These amendments revise the Technical Specifications to establish operating limits for Unit 1 cycle 4 operation and tighten leakage limits through the Steam Generator tubes.

OCONEE NUCLEAR STATION, UNIT NO. 1

Amendment No. 47
License No. DPR-38

ATTACHMENT TO LICENSE AMENDMENTS

Figure 2.1-1A

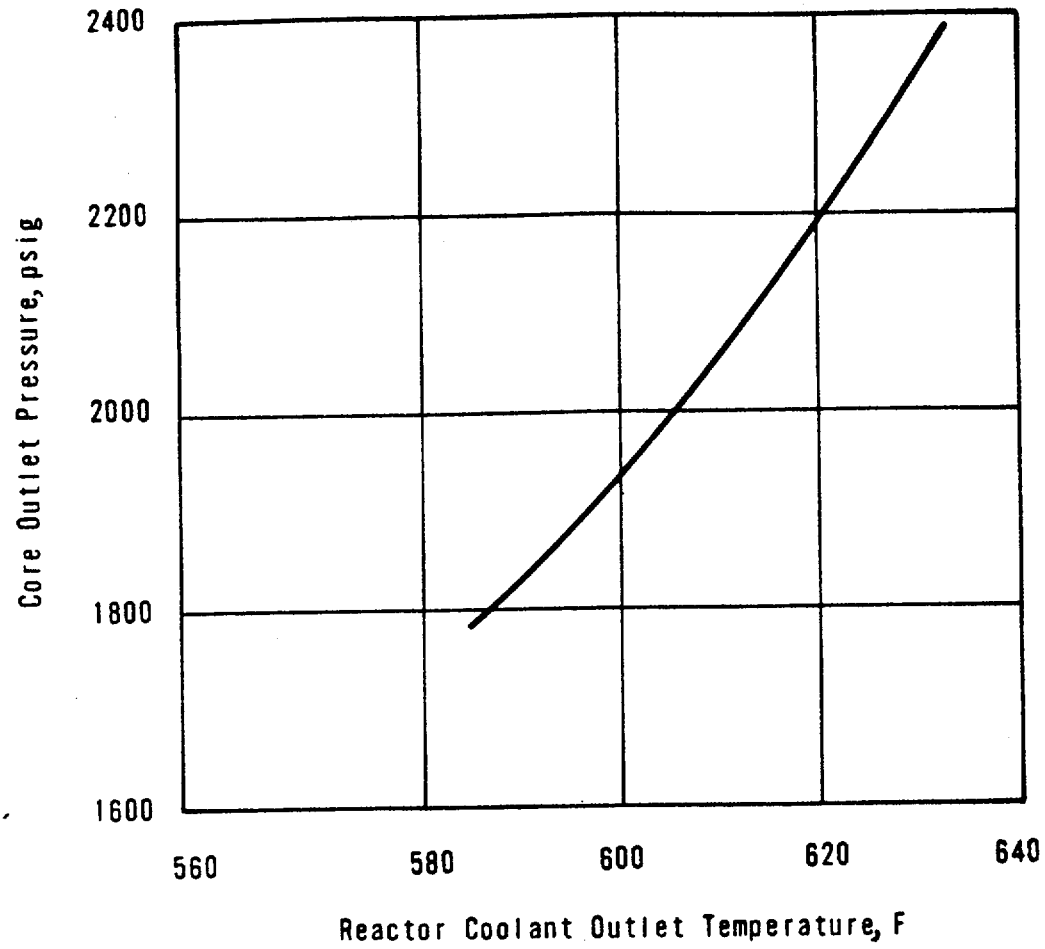
The curve presented in Figure 2.1-1A represents the conditions at which a minimum DNBR of 1.30 is predicted for the maximum possible thermal power (112 percent) when four reactor coolant pumps are operating (minimum reactor coolant flow is 106.5 percent of 131.3 x 10^6 lbs/hr.). This curve is based on the combination of nuclear power peaking factors, with potential effects of fuel densification and rod bowing, which result in a more conservative DNBR than any other shape that exists during normal operation.

The curve of Figure 2.1-1A is the most restrictive of all possible reactor coolant pump-maximum thermal power combinations shown in Figure 2.1-3A.

Figure 2.1-2A

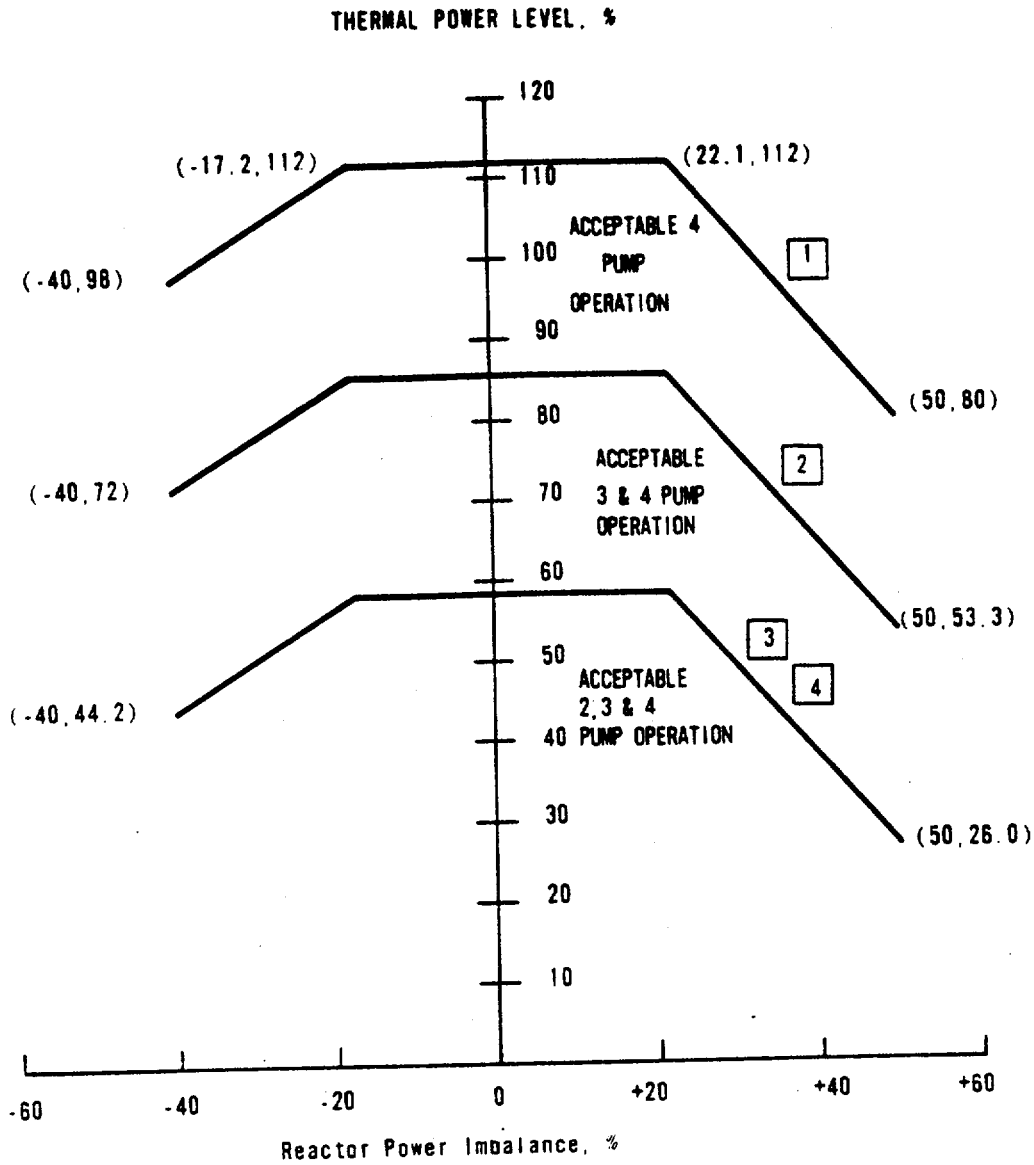
The curves of Figure 2.1-2A are based on the more restrictive of two thermal limits and include the effects of potential fuel densification and rod bowing:

1. The 1.30 DNBR limit produced by the combination of the radial peak, axial peak and position of the axial peak that yields no less than a 1.30 DNBR.

2. The combination of radial and axial peak that causes central fuel melting at the hot spot. The limit is 20.15 kw/ft for Unit 1.

The specified flow rates for Curves 1, 2, 3 and 4 of Figure 2.1-2A correspond to the expected minimum flow rates with four pumps, three pumps, one pump in each loop and two pumps in one loop, respectively.

OCONEE NUCLEAR STATION
Figure 2.1-3A

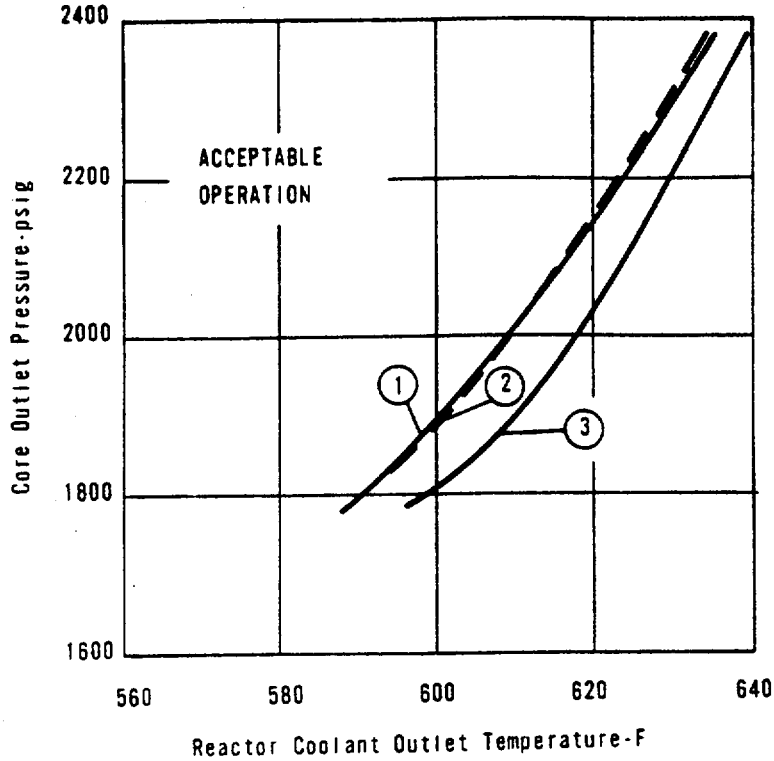
The maximum thermal power for three-pump operation is 85.3 percent due to a power level trip produced by the flux-flow ratio 74.7 percent flow x 1.055 = 78.8 percent power plus the maximum calibration and instrument error. The maximum thermal power for other coolant pump conditions are produced in a similar manner.

For Figure 2.1-3A, a pressure-temperature point above and to the left of the curve would result in a DNBR greater than 1.30.

PROTECTIVE SYSTEM MAXIMUM
ALLOWABLE SETPOINTS
UNIT 1
OCONEE NUCLEAR STATION
Figure 2.3-2A

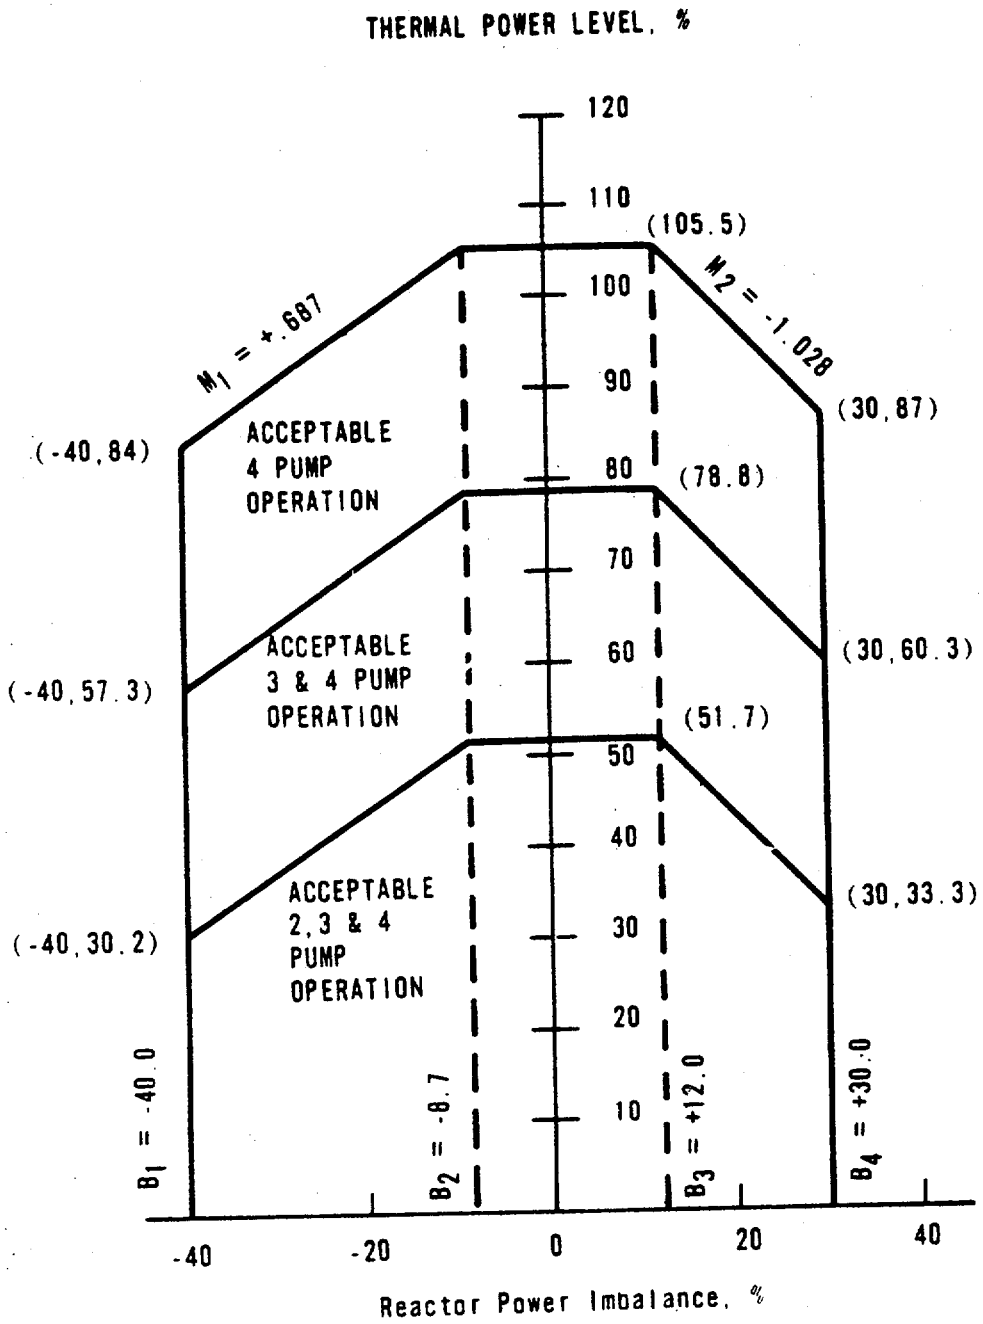
The power-imbalance boundaries are established in order to prevent reactor thermal limits from being exceeded. These thermal limits are either power peaking kw/ft limits or DNBR limits. The reactor power imbalance (power in the top half of core minus power in the bottom half of core) reduces the power level trip produced by the power-to-flow ratio such that the boundaries of Figure 2.3-2A - Unit 1 are produced. The power-to-flow ratio reduces the power
2.3-2B - Unit 2
2.3-2C - Unit 3

level trip and associated reactor power/reactor power-imbalance boundaries by 1.055%-Unit 1 for a 1% flow reduction.
1.055%-Unit 2
1.07% -Unit 3
For Units 1 and 2 the power-to-flow reduction ratio is 0.949, and for Unit 3, the power-to-flow reduction factor is 0.961 during single loop operation.

Figure 3.5.2-3A1

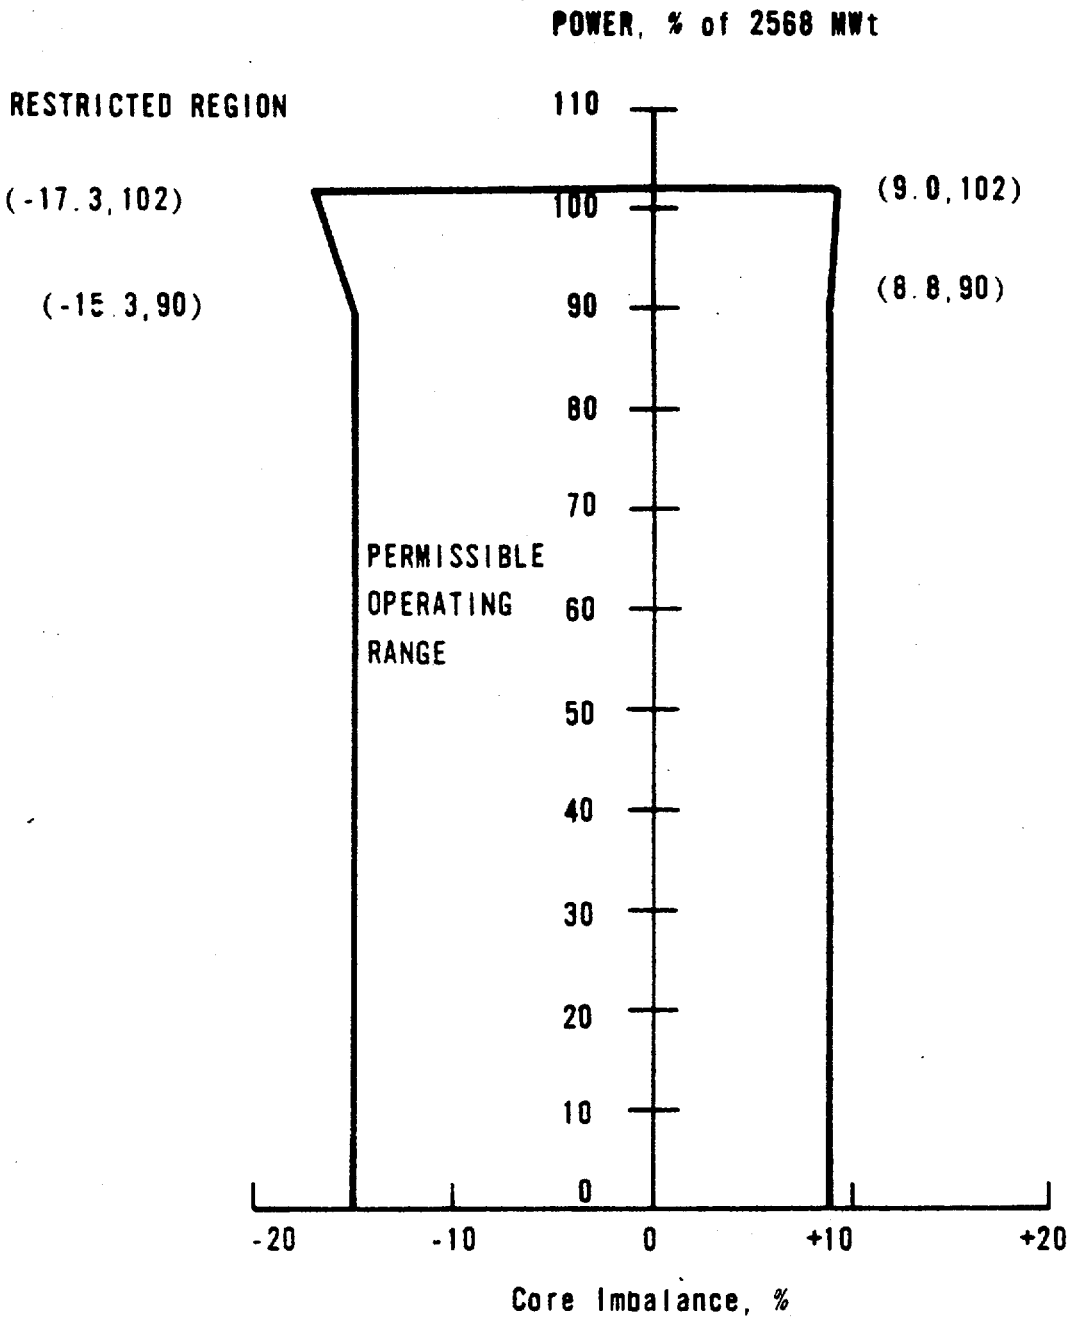
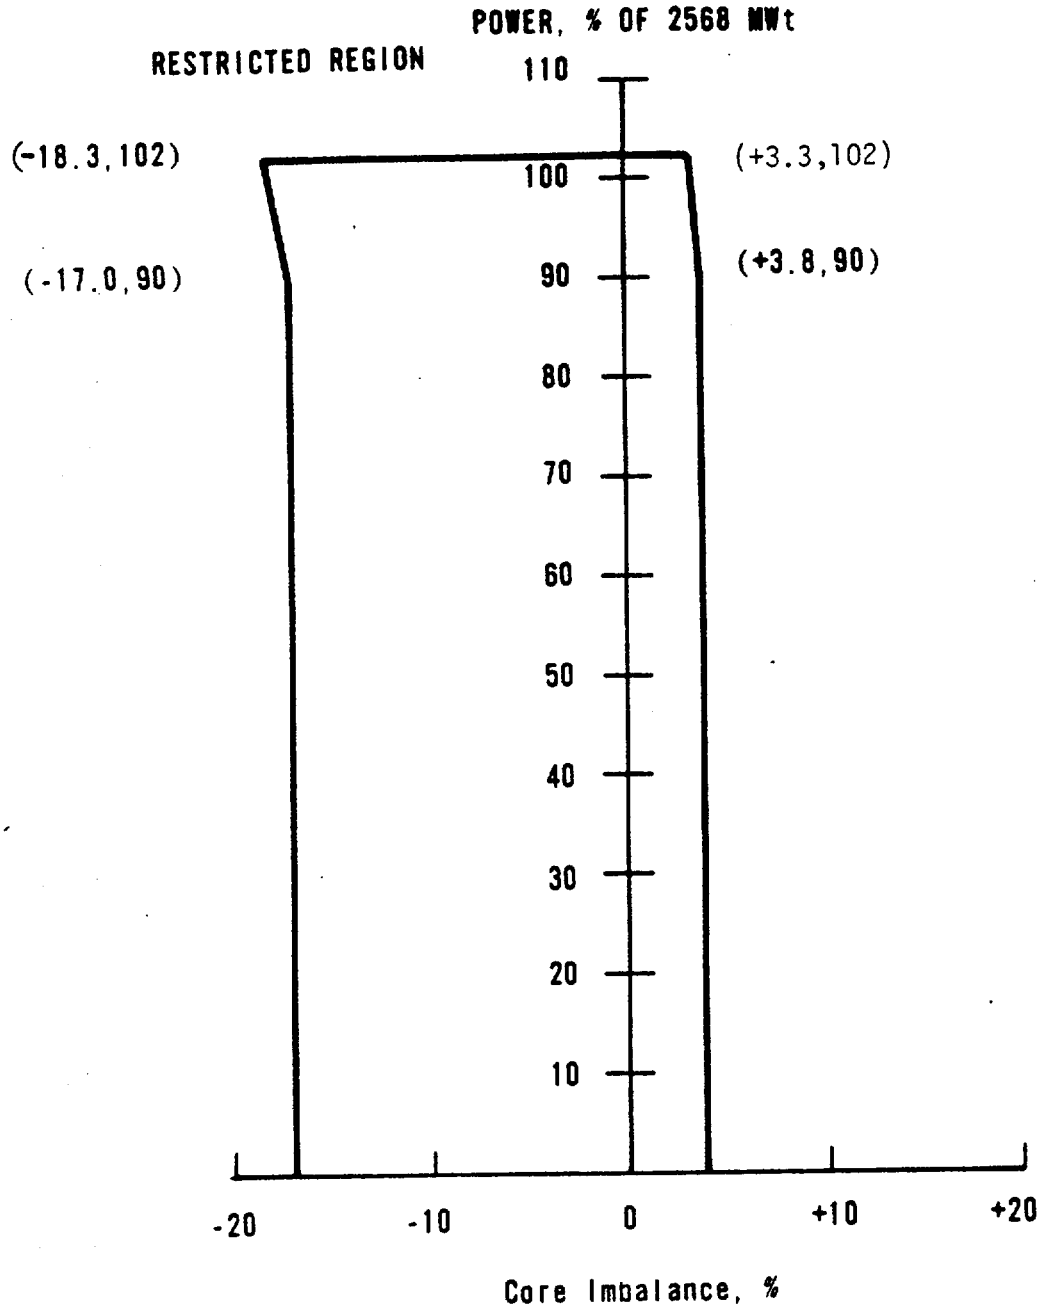
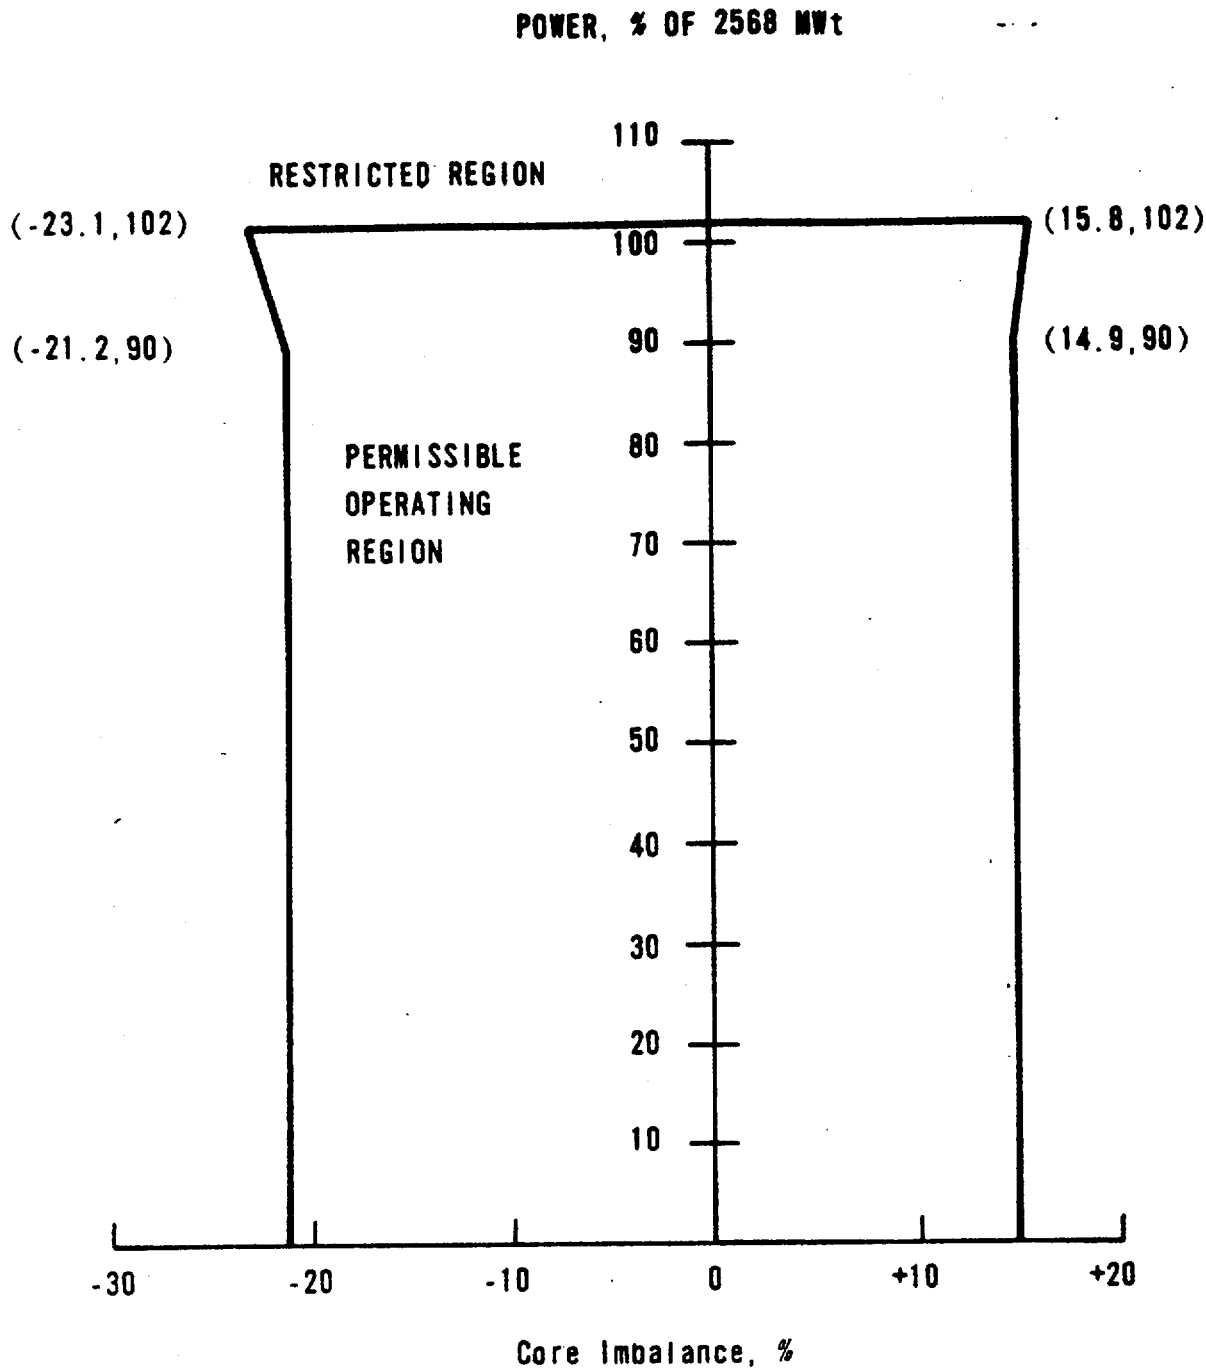
The power-imbalance envelope defined in Figures 3.5.2-3A1, 3.5.2-3A2, 3.5.2-3A3, 3.5.2-3B1, 3.5.2-3B2, 3.5.2-3B3, 3.5.2-3C1, 3.5.2-3C2 and 3.5.2-3C3 is based on LOCA analyses which have defined the maximum linear heat rate (See Figure 3.5.2-5) such that the maximum clad temperature will not exceed the Final Acceptance Criteria. Corrective measures will be taken immediately should the indicated quadrant tilt, rod position, or imbalance be outside their specified boundary. Operation in a situation that would cause the Final Acceptance Criteria to be approached should a LOCA occur is highly improbable because all of the power distribution parameters (quadrant tilt, rod position, and imbalance) must be at their limits while simultaneously all other engineering and uncertainty factors are also at their limits.** Conservatism is introduced by application of:
